# **BROOKMAN ROAD ALIGNMENT CROSS SECTIONS**

OCTOBER 2019  
DRAFT FOR INTERNAL DISCUSSION  
BROOKMAN ROAD ALIGNMENT STUDY - THIRD ROADWAY ALIGNMENT

# **ADDENDUM TO THE BROOKMAN ADDITION CONCEPT PLAN**

City of  
**Sherwood**  
Oregon

Figure 2: 5-Lane Cross Section

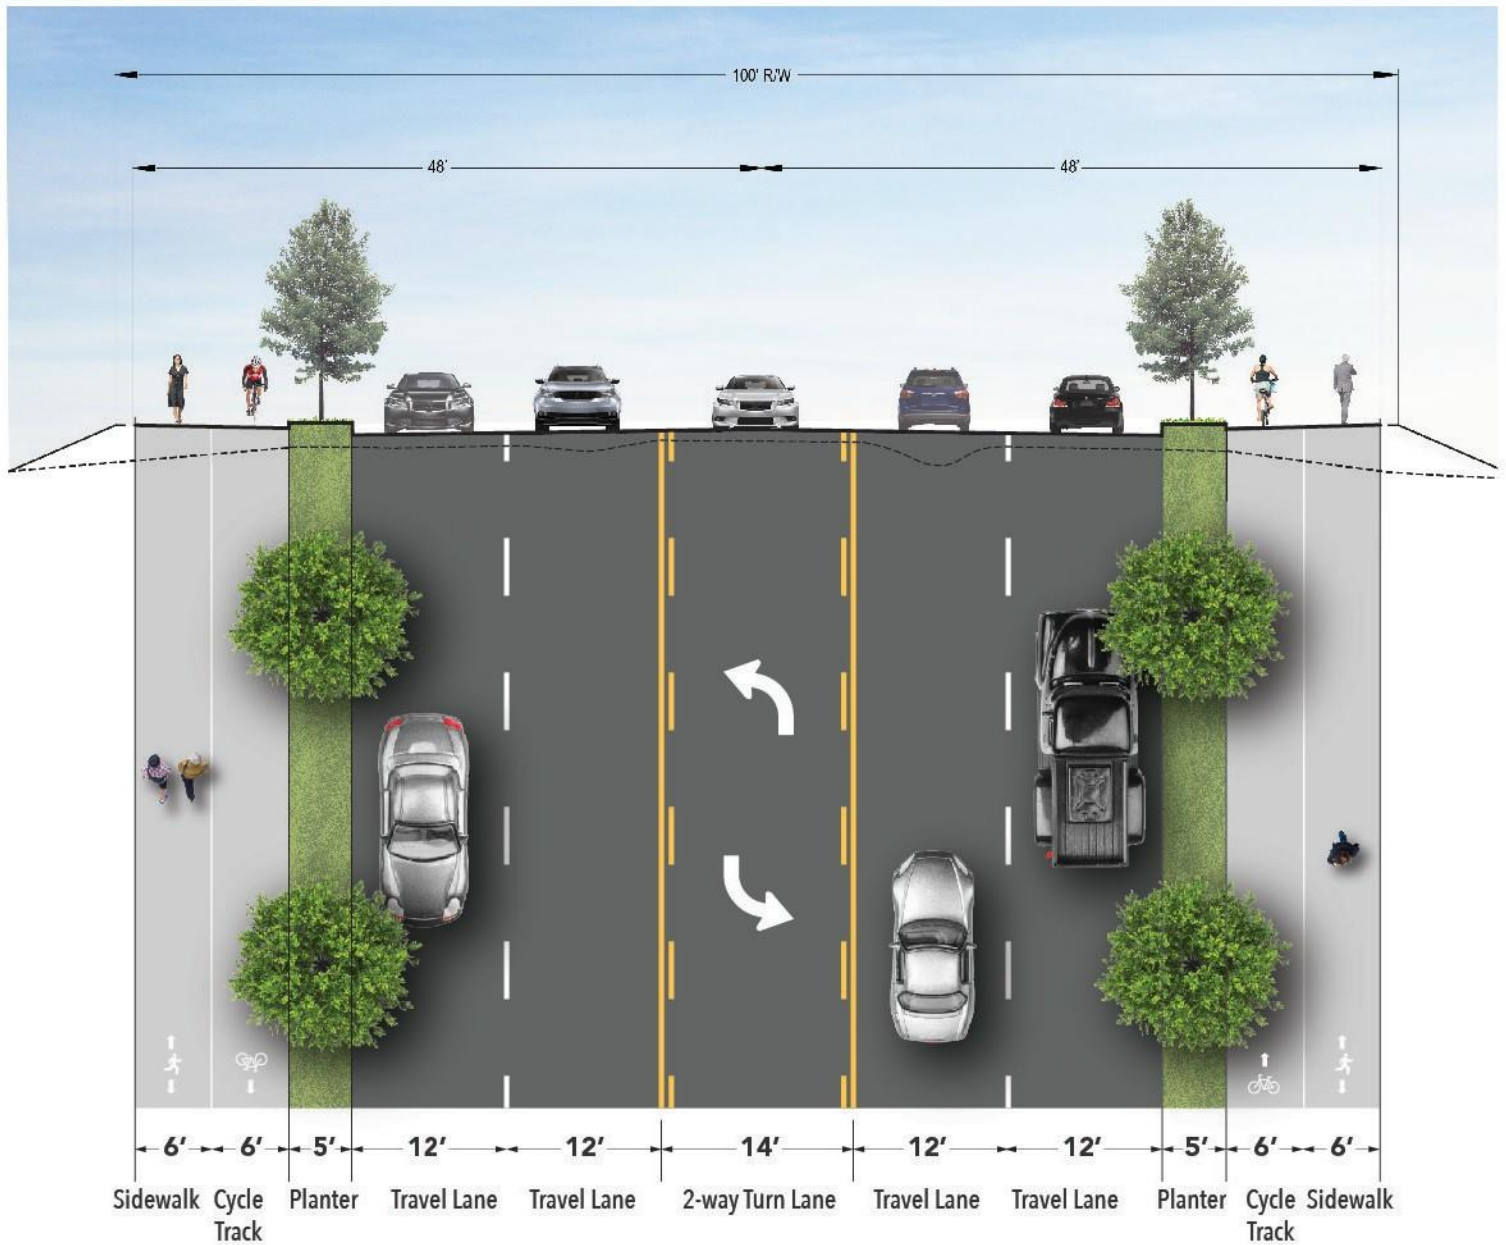
- » **Long Term Design.** The 5-lane street design should remain as the official long-term design with an arterial designation.

*Further Action:* Amend pages 5, 18, 20, 21-24 to include references to a future 5-lane road. Include the 5-lane cross section graphic as a figure.

Figure 4: 3-Lane Transitional Road Cross Section

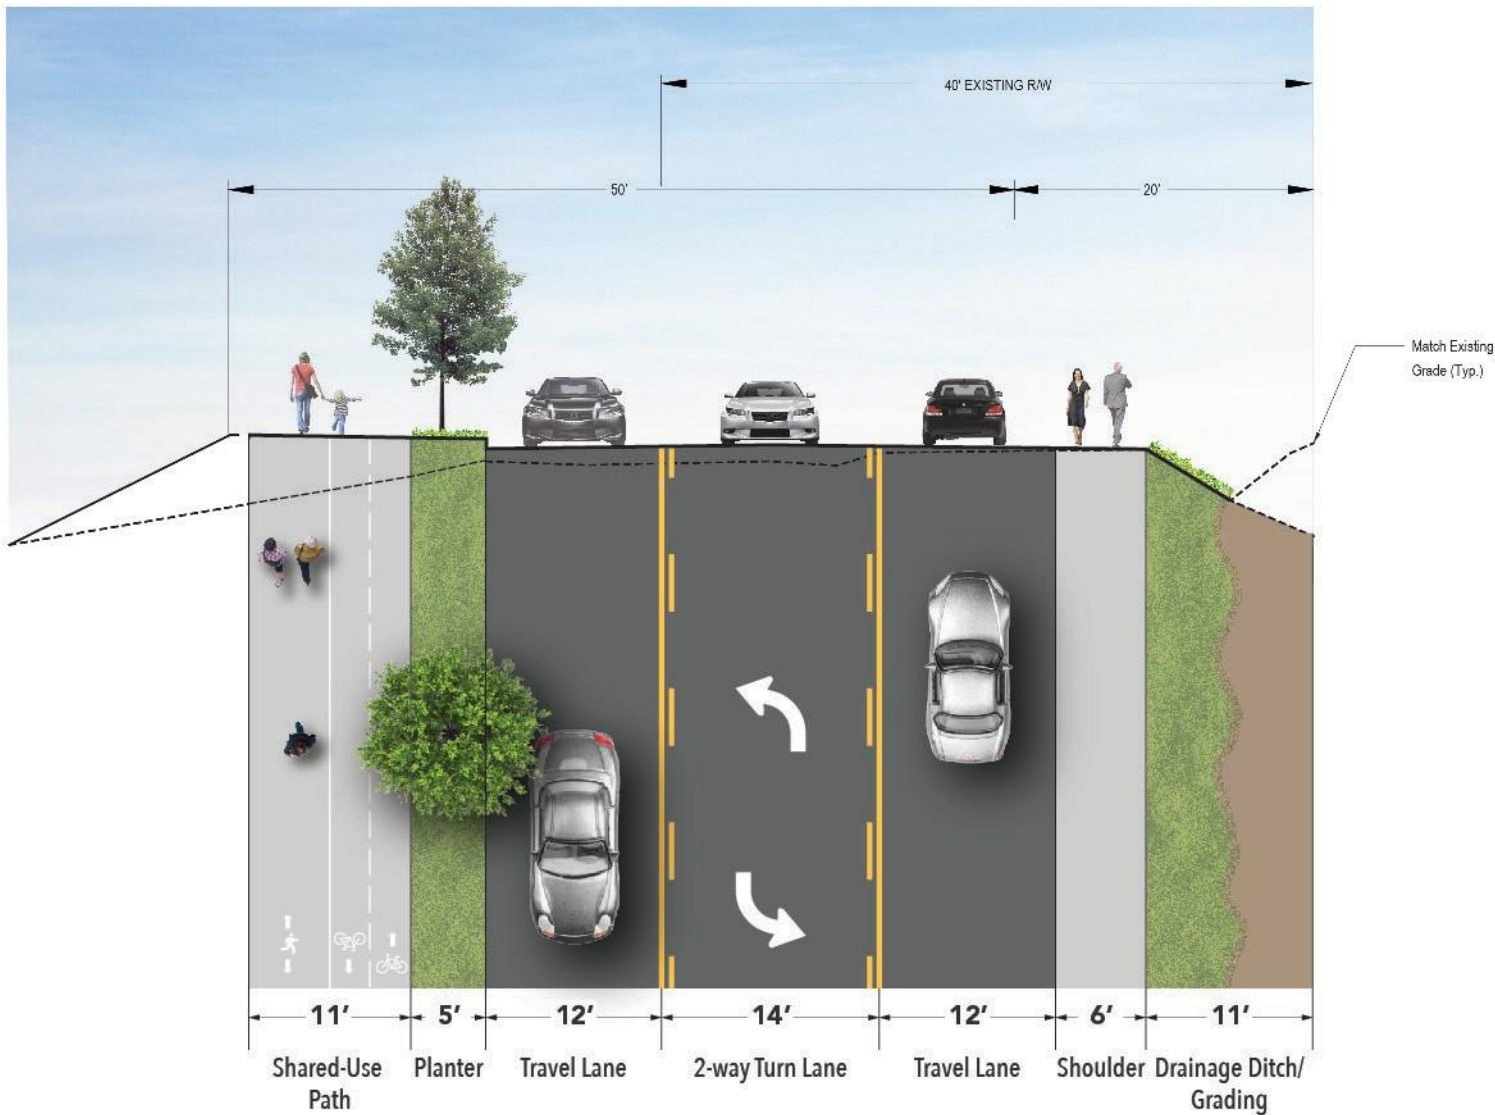
- » **Interim Design.** The 3-lane alternative road design (Option 3) should be used in the interim until a full 5-lane road is needed. Adding dual westbound left turn lanes would mitigate 99W and Brookman Road and allow the intersection to operate within the proper jurisdictional standard for level of service and volume to capacity ratio.

The interim design would feature an 11-foot shared use path on the northern side of the road.

*Further Action:* Amend text in the existing concept plan pages 5, 18, 20, 21-24 to reflect the interim design. Replace map on page 23 with new recommended road alignment. Update other maps within the concept plan to show the new alignment. Include the 3-lane alternative cross-section graphic as a figure.

Figure 9: Recommended Rail Crossing

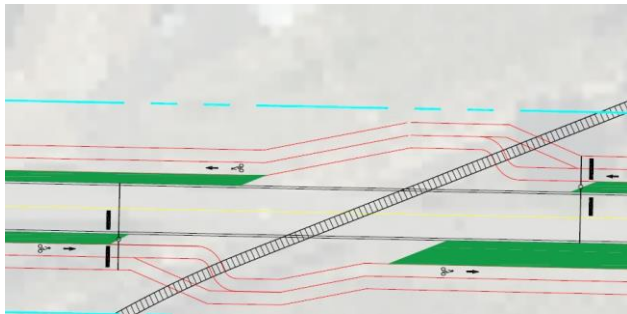
- » **Rail Crossing.** The railroad crossing should be designed to protect bike and pedestrian users by having a multi-use path cross the tracks at a 90-degree angle.

*Further Action:* Include rail crossing designs as figure in concept plan. Add bullet point discussing recommended road alignment in relation to the railroad on page 18.
